Cam Cover Breather Safety

Technical Bulletin # FRA-2020-EN004-00

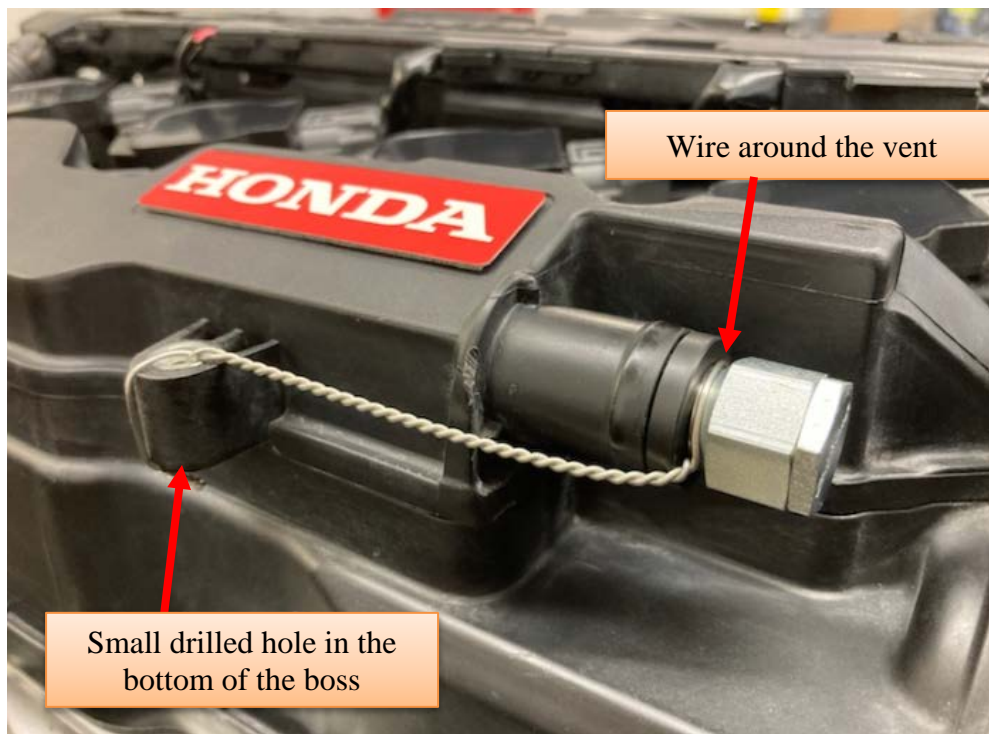
After the implementation of the cam cover breather for the 2020 season, there have been instances where the breather assembly has come out of the cam cover and been lost on track. This can cause a significant amount of oil to leak from the car as well as a possible small projectile exiting the rear of the car.

From the 2020 Barber event and onward, it will be required that the breather is properly safety wired to the cam cover as shown in the photo below. Competitors may need to drill a small hole in the bottom of the threaded boss as indicated to allow the wire to pass through. All cars must have this added safety wire at tech inspection for each event.
